Minutes - Executive Policy Committee - October 15, 2008

Item No. 3 Zoning Agreement Amendment - 5 Scurfield Boulevard (River Heights-Fort Garry Ward) File ZAA 16/2008

Planning, Property and Development Department Report

DATE:	September 11, 2008
FILE:	**ZAA 16/08**
RELATED FILES:	DAV 08-131179/D, DASZ 44/79
SUBJECT:	To amend the Zoning Agreement affecting the land shown outlined below by deleting the width requirement stated in Clause 5 and replacing it with "1.2 metres (four feet)".
LOCATION:	**5 Scurfield Boulevard, at Waverley Street**
LEGAL DESCRIPTION:	LOT 6 BLOCK 7 PLAN 15345 16/23 ST V OTM
APPLICANT:	Frieder Aldinger, MMM Group Limited 93 LOMBARD AVE SUITE 111 WINNIPEG MB R3B 3B1
OWNER:	2253062 MANITOBA LIMITED C/O MMI COMMERCIAL REAL ESTATE LTD ATTN: LINDSEY SAUNDERS 430 DOVERCOURT DR UNIT A WINNIPEG MB, R3Y 1N4
RECOMMENDATION:	***Not* Proceed With.**

Figure 3: Looking South at Existing Trees at 5 Scurfield Boulevard,
September 2, 2008 photograph

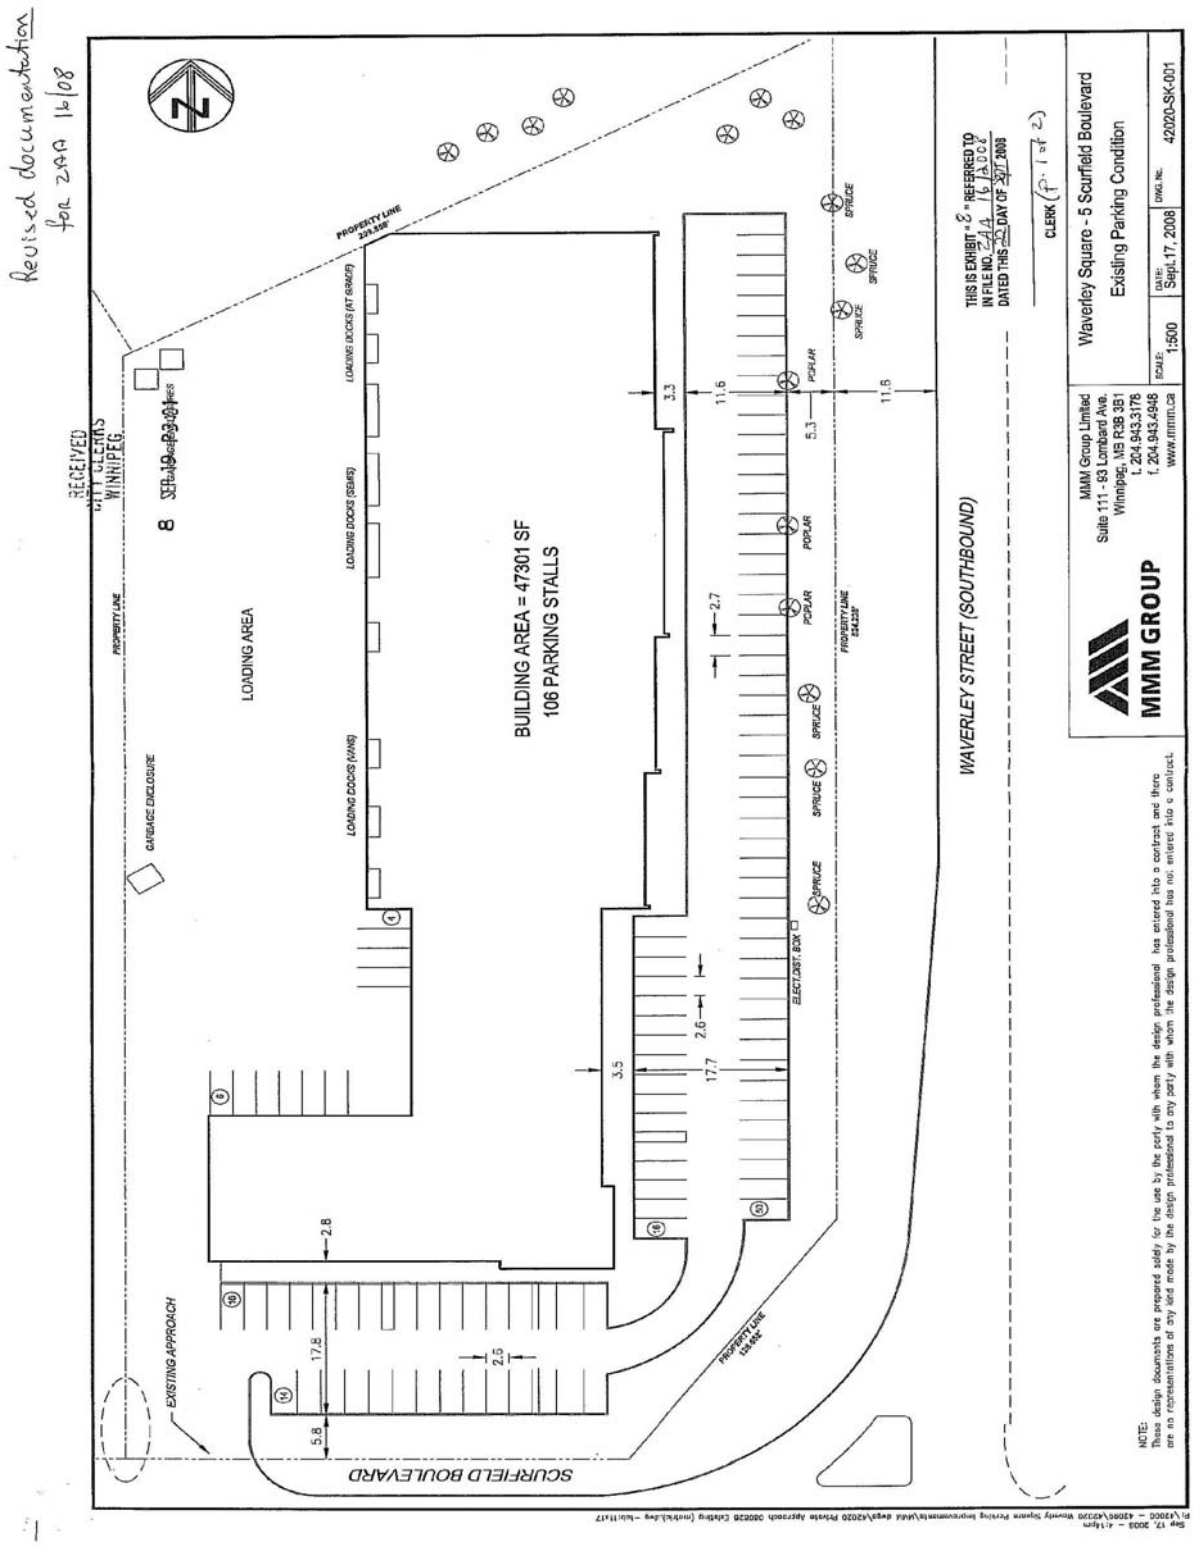
Figure 3 shows some of the aforementioned trees, all of which are in the corner side-yard.

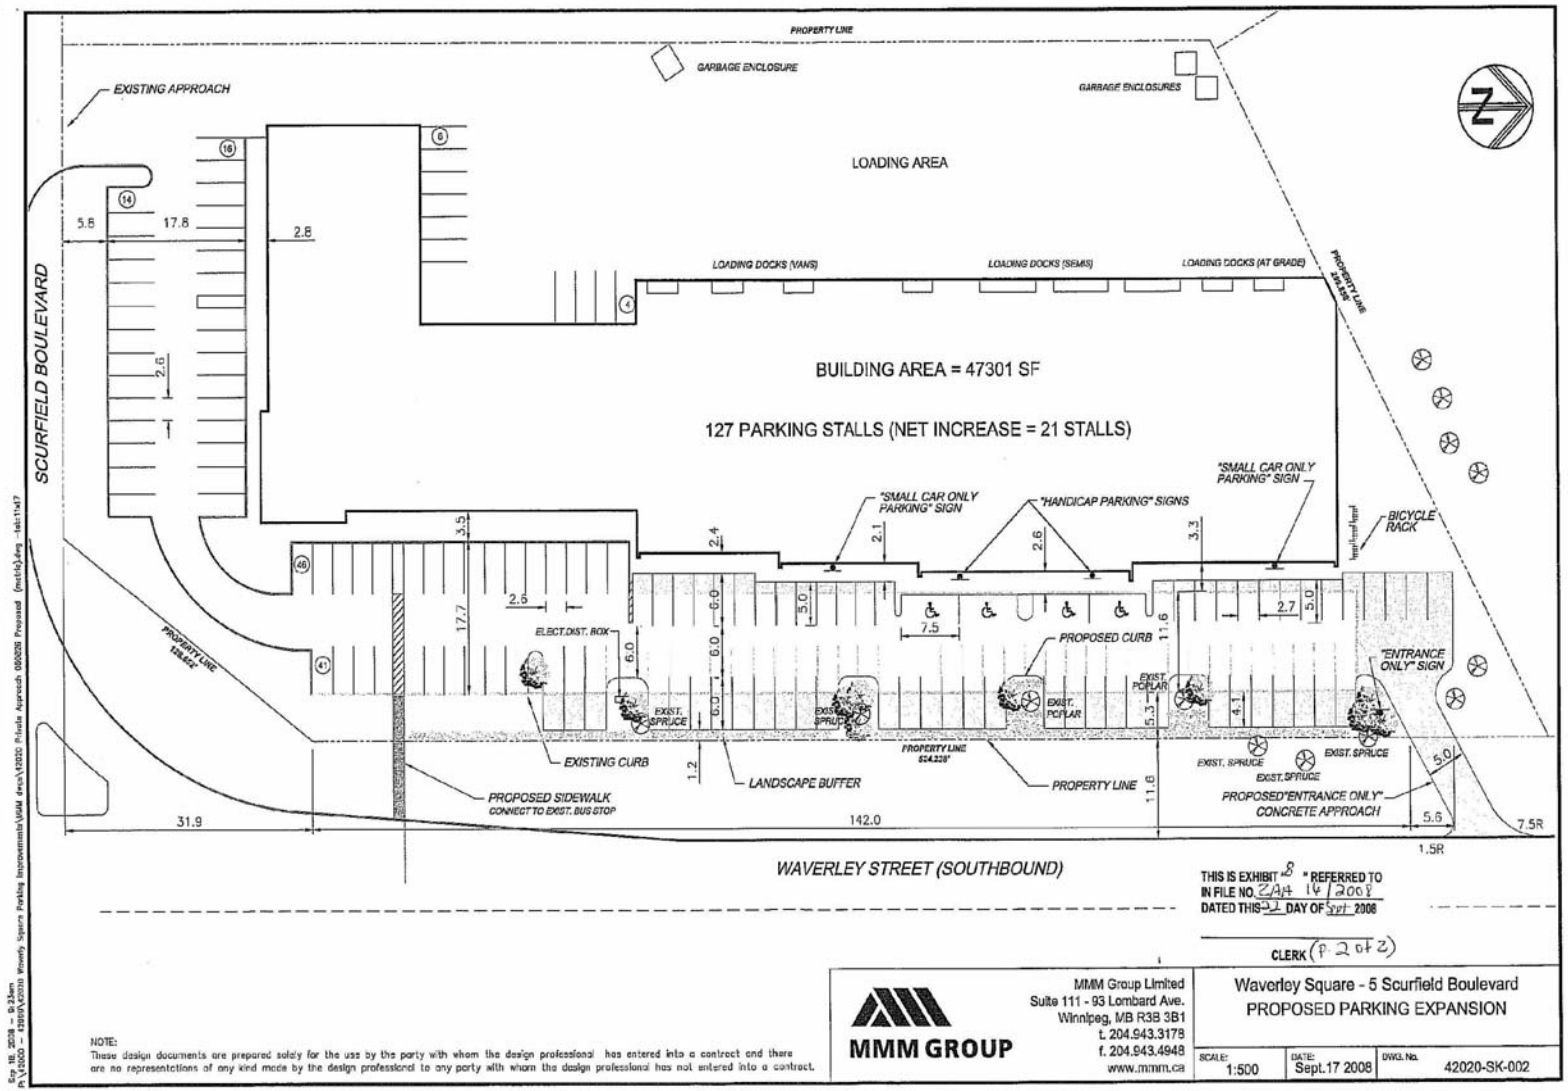
The proposed location for the bicycle parking, illustrated in Sheet 2 of 2 of a site plan submitted in connection with the aforementioned File DAV 08-131179/D, is not visible from any main entrance to the units at 5 Scurfield Boulevard or to windows in the building on the subject land. In order to provide a sense of security, personal safety and convenience, the bicycle parking should be clearly visible to people in the building on the subject land and the main entrances should be clearly visible to people at the bicycle parking area(s).

The proposed four foot deep yard adjacent to Waverley Street is not compatible with land in the immediate vicinity of the subject land and the larger context of Waverley Street, between McGillivray and Bishop-Grandin Boulevards, because:

- lots immediately north, south across Scurfield Boulevard or east across Waverley Street have yards adjacent to Waverley with depths ranging from 18 to 27 feet, which is significantly more than the proposed yard depth; and
- almost all yards adjacent to Waverley Street, between McGillivray and Bishop-Grandin Boulevards, are at least 15 feet deep, which is also significantly more than the proposed yard depth.

While it is recognized that the preservation of several mature trees would mitigate, to some degree, the proposed east yard depth of only four feet it is noted that 31 parking spaces would be adjacent to the east yard, showing that most of the east yard would be four feet deep.

Therefore, **the Planning and Land Use Division recommends that the zoning agreement amendment application – File ZAA 16/08 – *not* be proceeded with** because the Division is of the opinion that reducing the corner side-yard depth requirement in Zoning Agreement DASZ 44/79 from 19.7 feet to four feet:

- is not the minimum modification of Zoning Agreement DASZ 44/79 required to relieve the injurious effect of said agreement on the applicant's property; and
- would, if the minimum yard depth requirement is varied accordingly, allow the creation of a yard that would not be compatible with the area in which the property to be affected is situated.

Lastly, the Planning and Land Use Division encourages the applicant to provide bicycle parking, as recommended in the "Zoning" section of this report, and a pedestrian route connecting a Winnipeg Transit bus stop to the building on the subject land.
